# **Review of London Oxford Airport Proposal**

**December 2003**

Halcrow Group Ltd

**Figure 1 - Demand For Air Travel By District At London Oxford Airport**

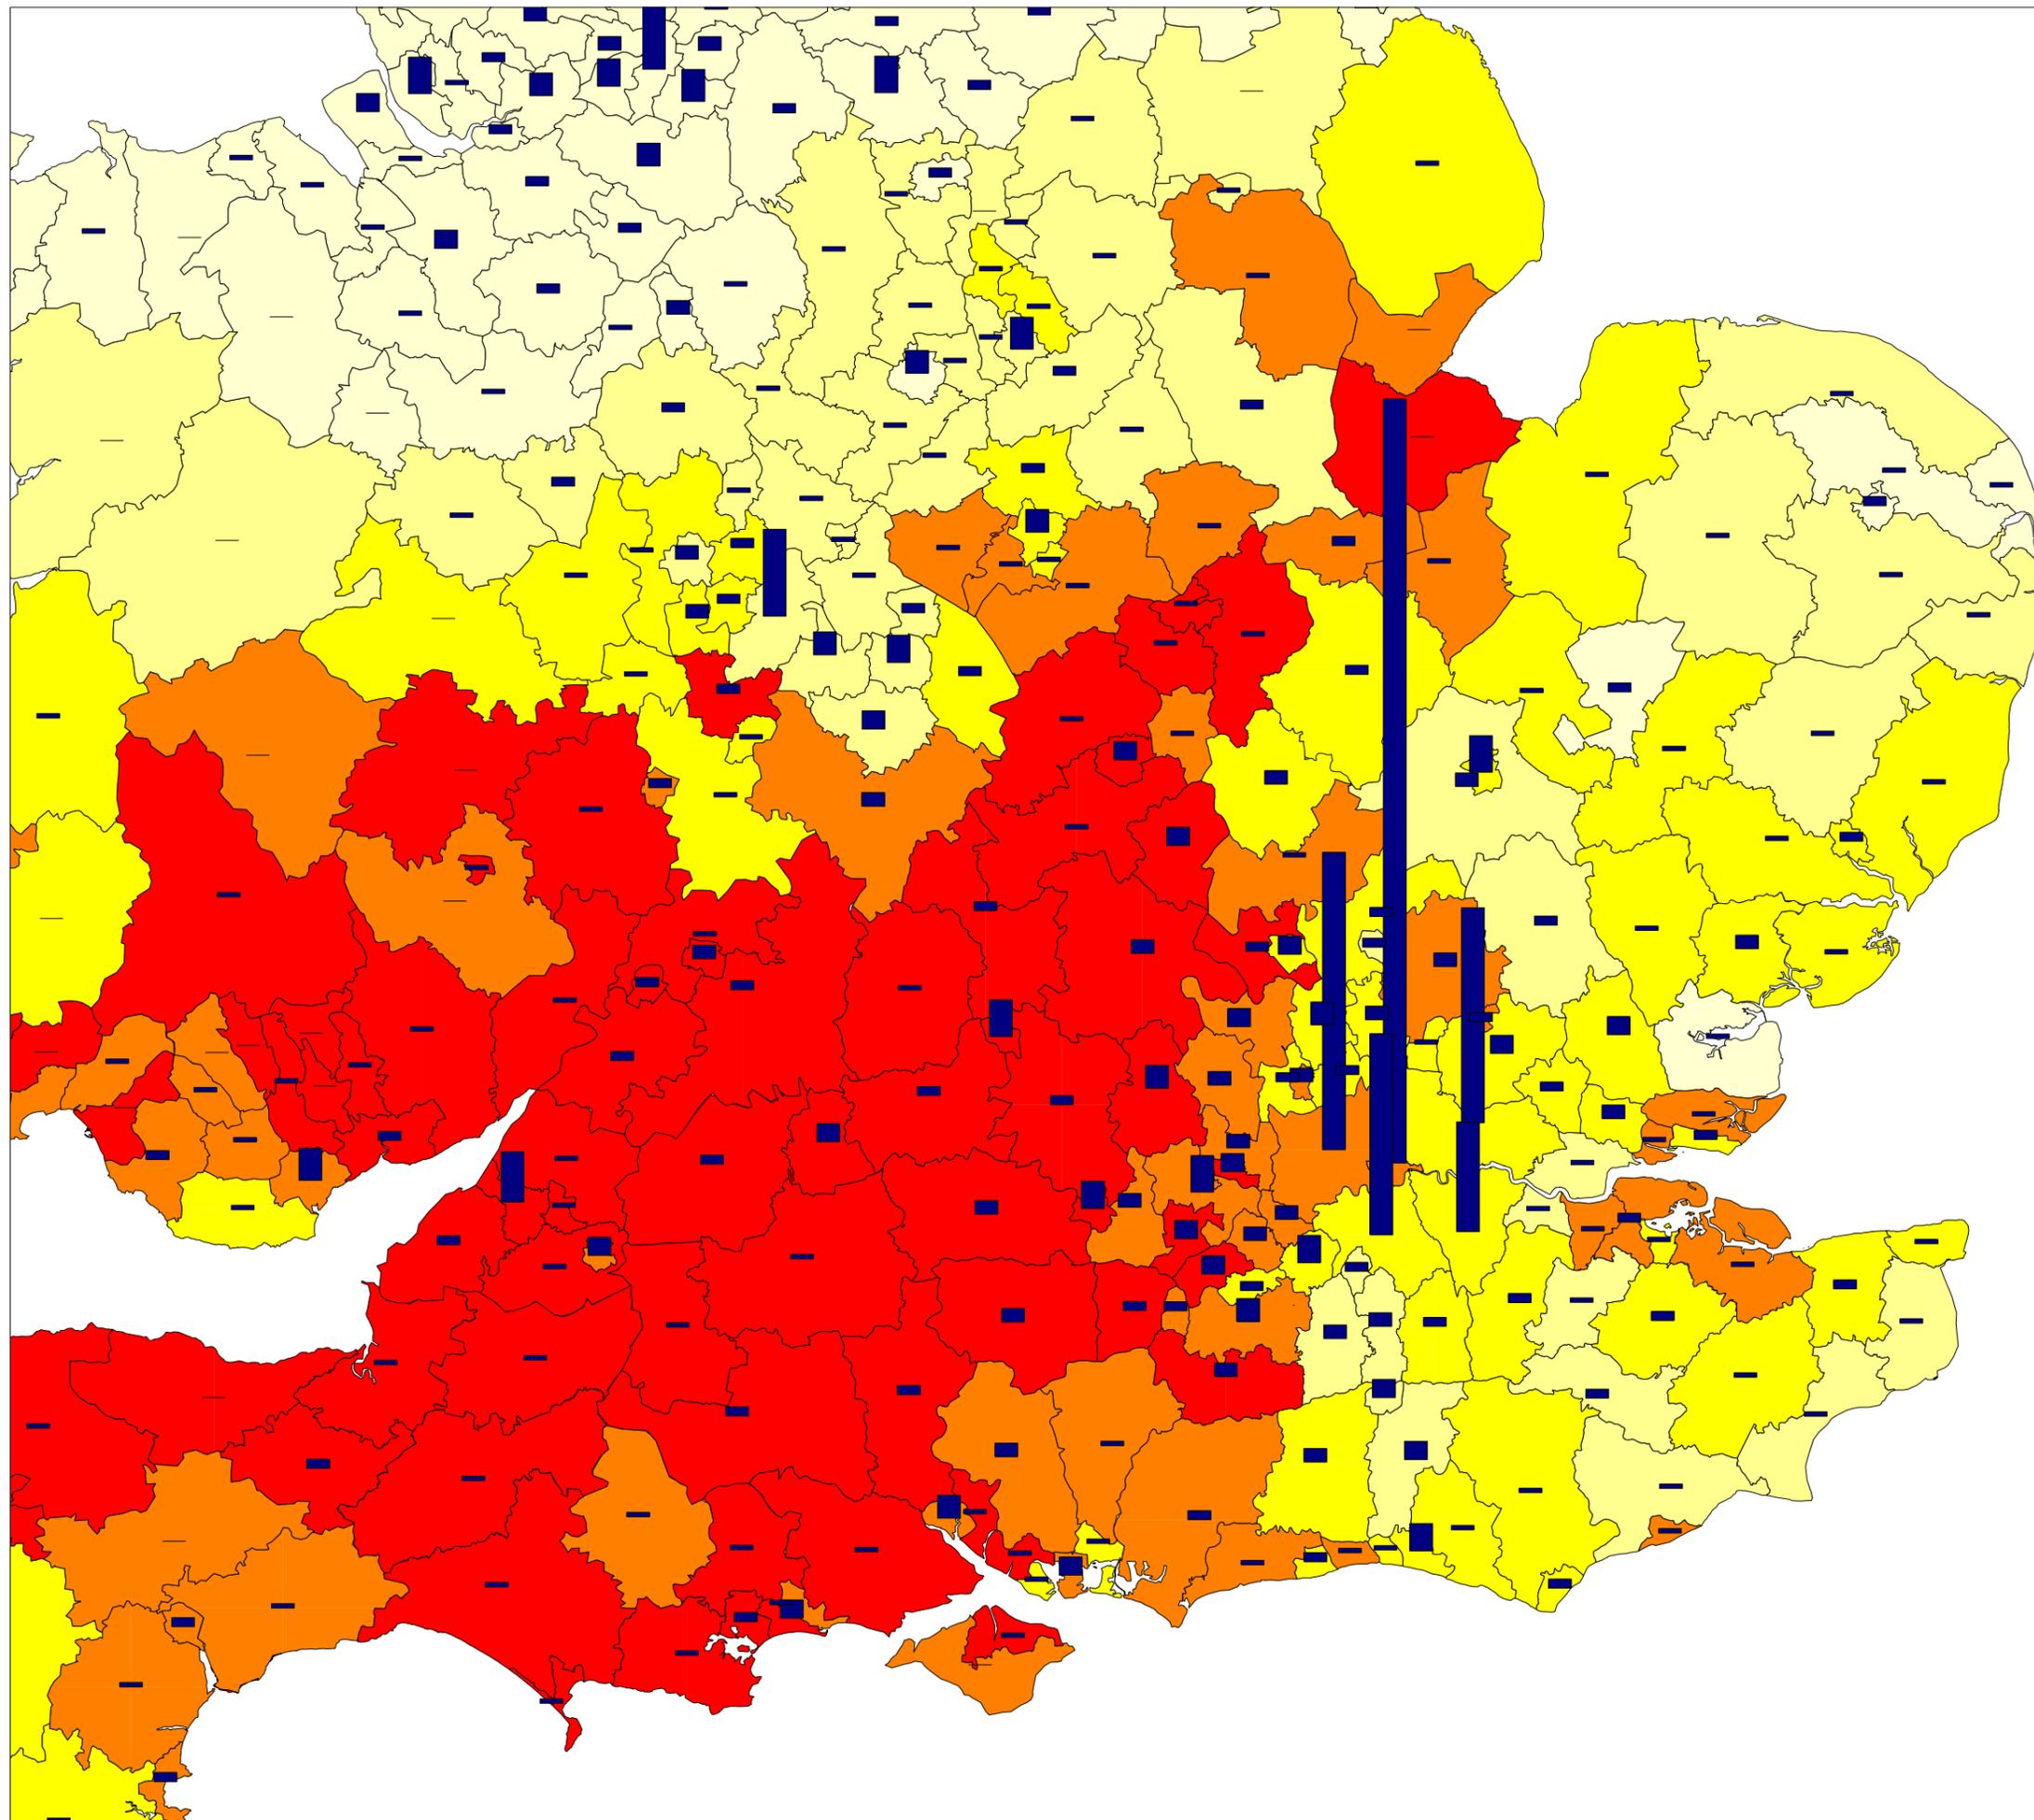
Figure 1 shows the demand for air travel by district, and the four quadrants of London (North West, North East, South West and South East) plus Central London represented by bars, and the percentage of this demand from each zone that is forecast to use LOx in 2030 represented by graduated shading.

The height of the bars for the London area show that it is the prime area from which airport demand originates. London Oxford's core catchment area is mainly to the North, West and South West of the airport, with the London airports forecast to maintain the core of the London and South East demand.
